# Winterbourne Wind Farm

Amendment Report

3 October 2024

0526676

**1-3 EIS Project Layout**

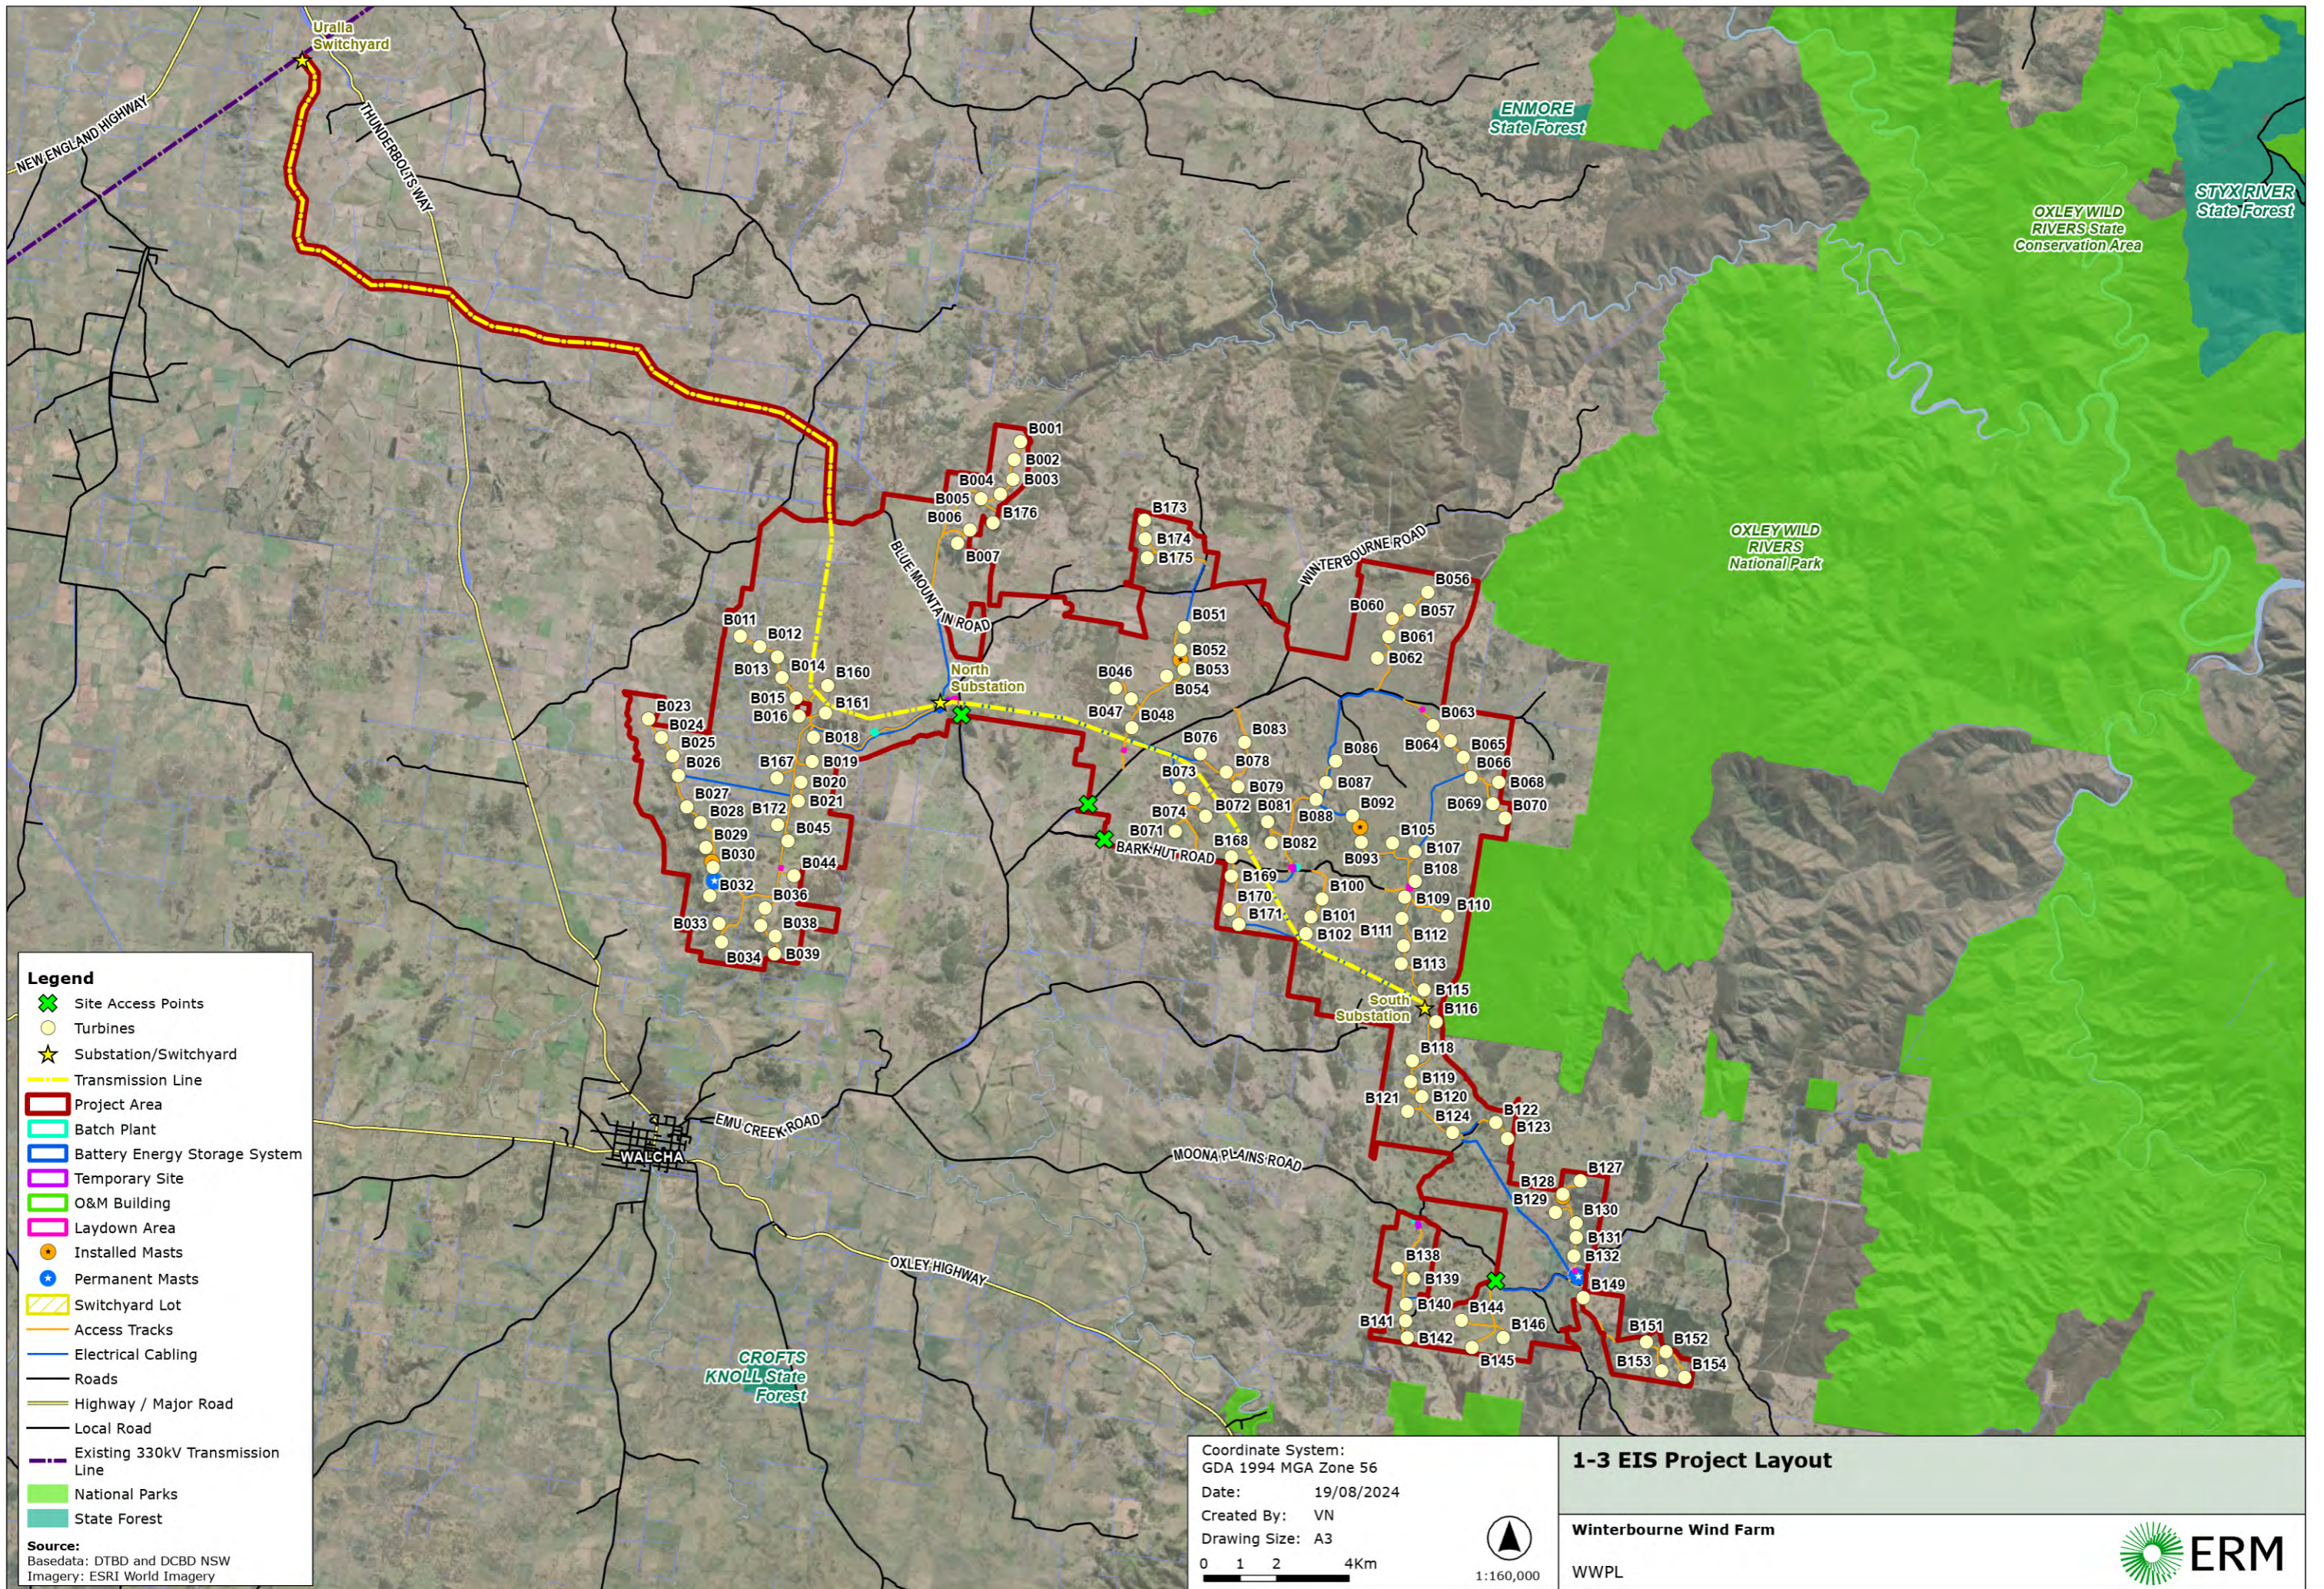
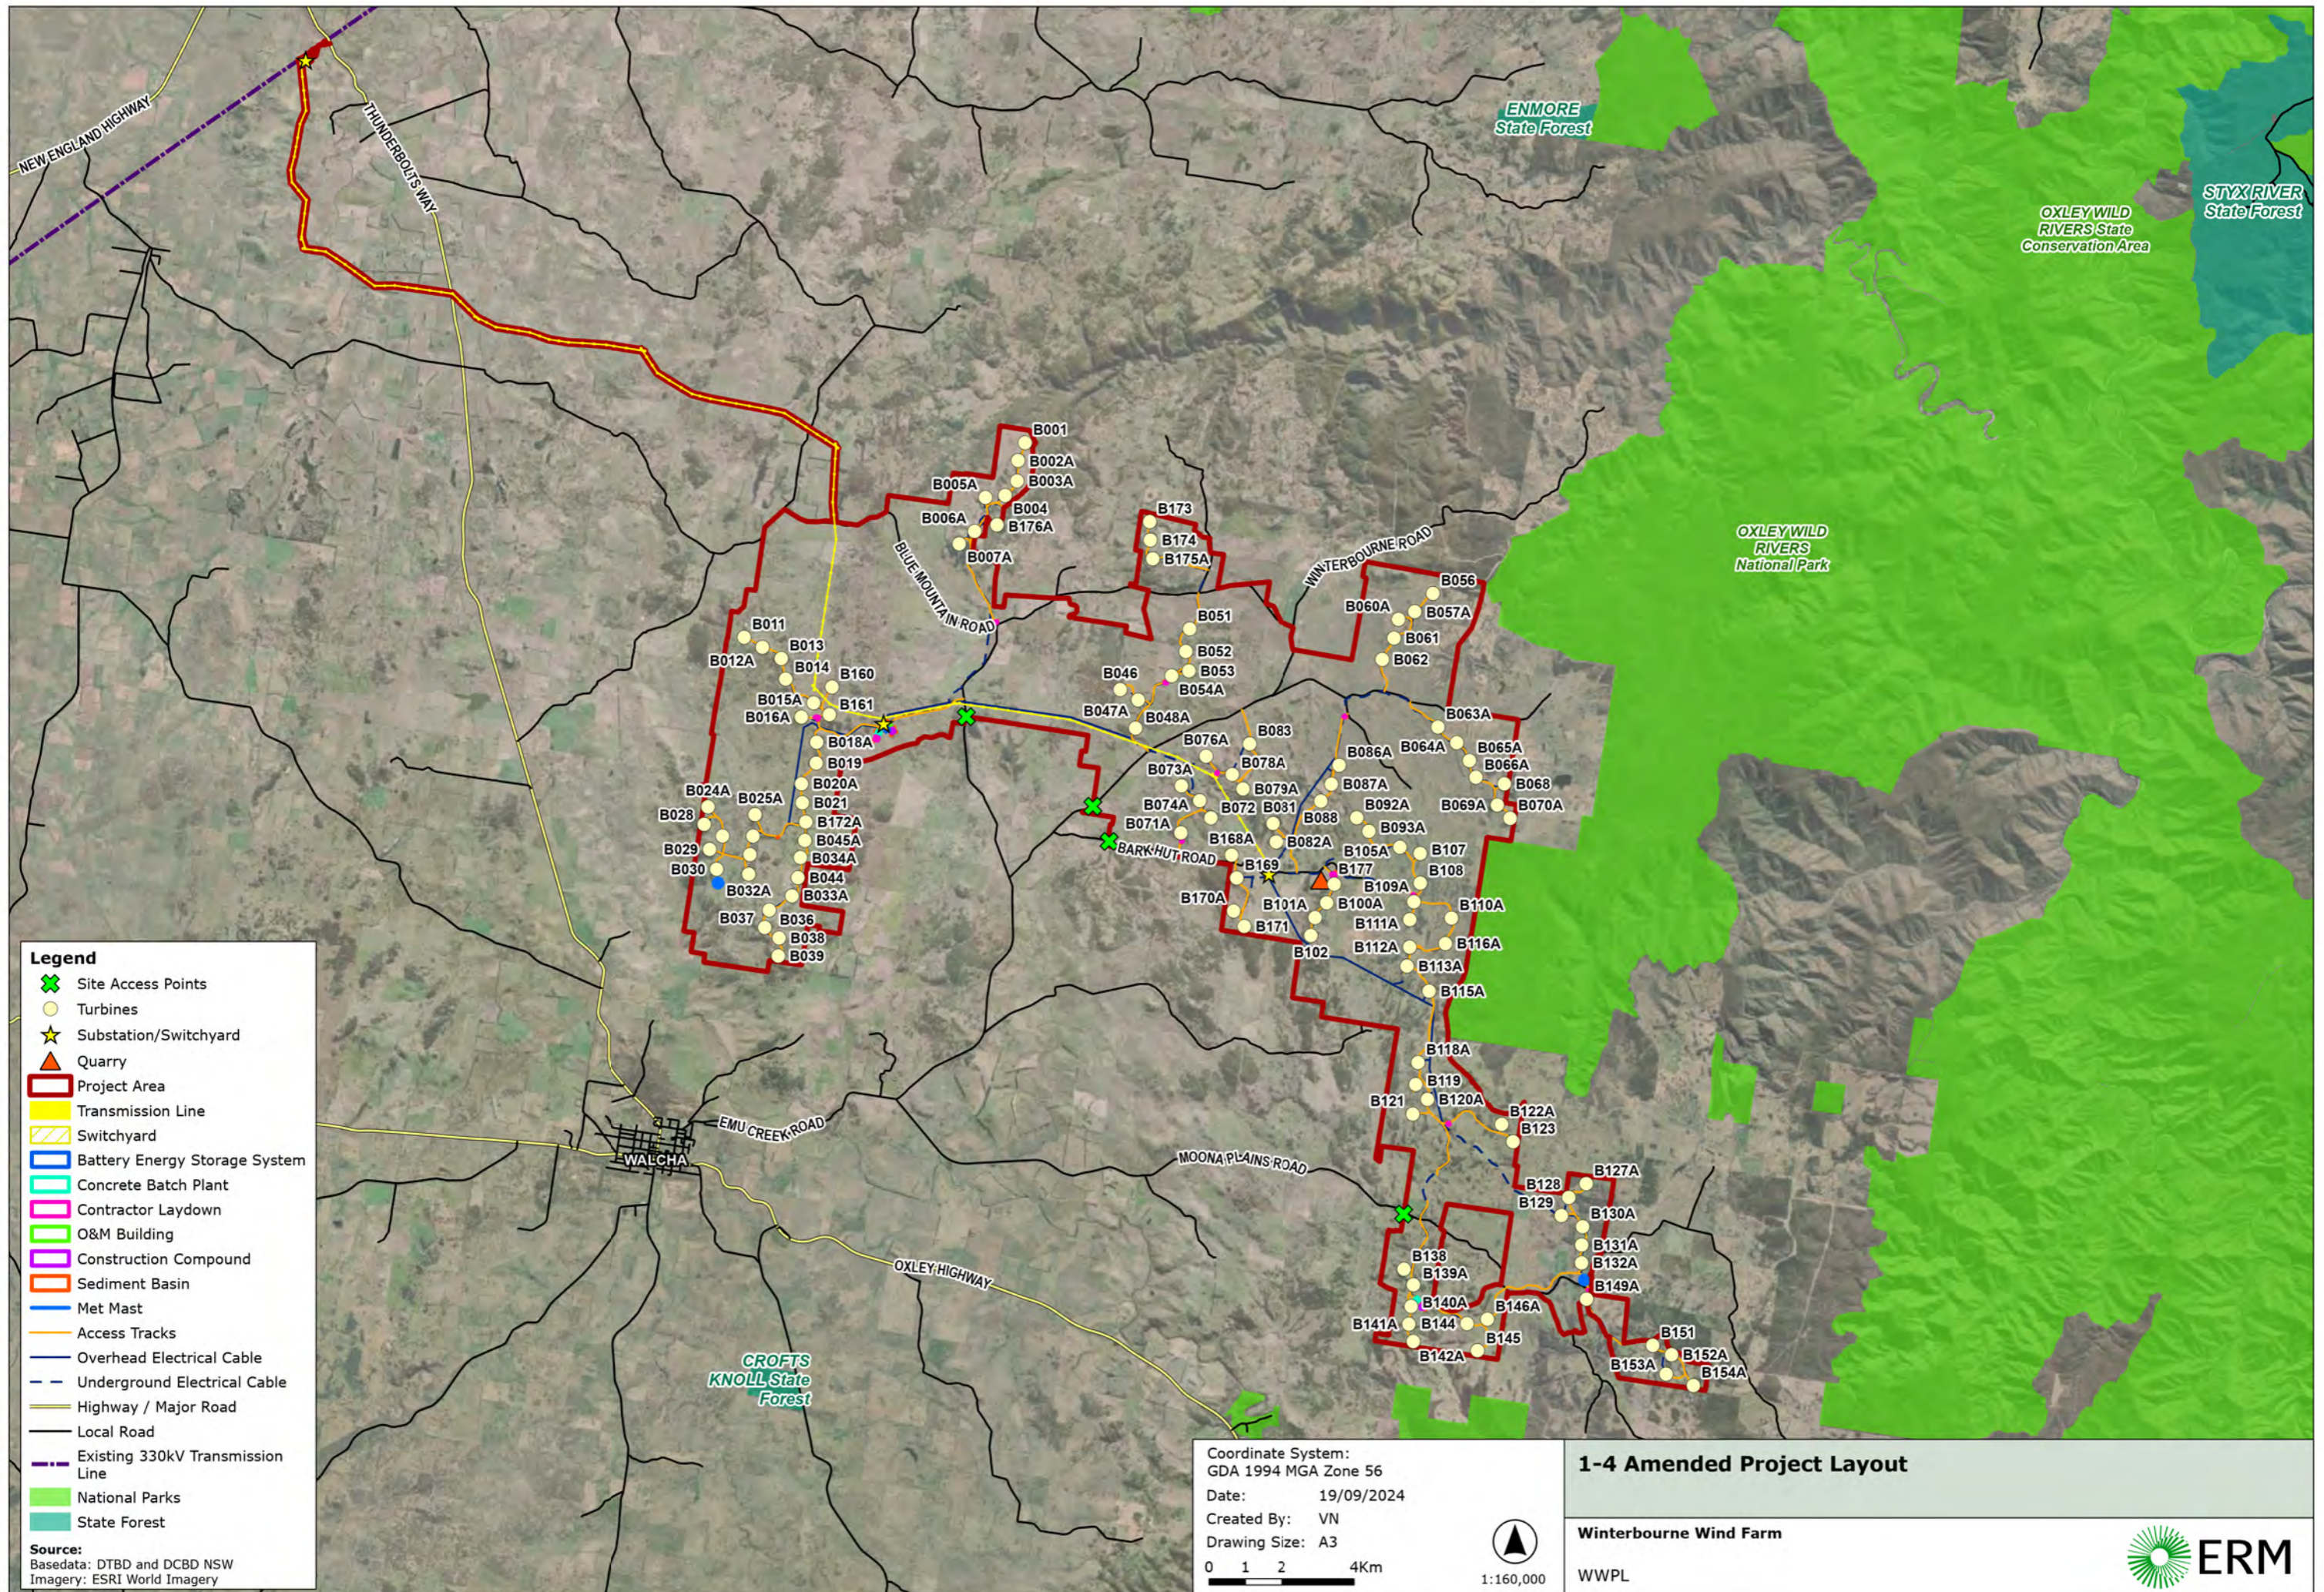
The Project layout as presented in the EIS is provided in **Figure 1-3**.

The Applicant has made amendments to the Project informed by submissions received during EIS public exhibition and constraints identified during the development of the EIS (**Figure 1-4**). The key changes include:

- WTG configuration updates:
  - 21 WTG relocations (moved >100 m);
  - 52 WTG refinements (moved <100 m); One (1) WTG added;
  - Two (2) WTGs removed;
- Project area updates including the addition on two parcels and removal of thirteen parcels of land;
- Realignment of site access locations and internal access tracks, and electrical reticulation;
- Relocation of both substations, Operations and Maintenance (O&M) facility, construction compound, BESS and laydown areas;
- Inclusion of on-site quarry to supply gravel, aggregates and potentially bedding material required for Project construction; and
- New transport route to avoid Oxley Highway for inbound Over Size Over Mass (OSOM) vehicles.
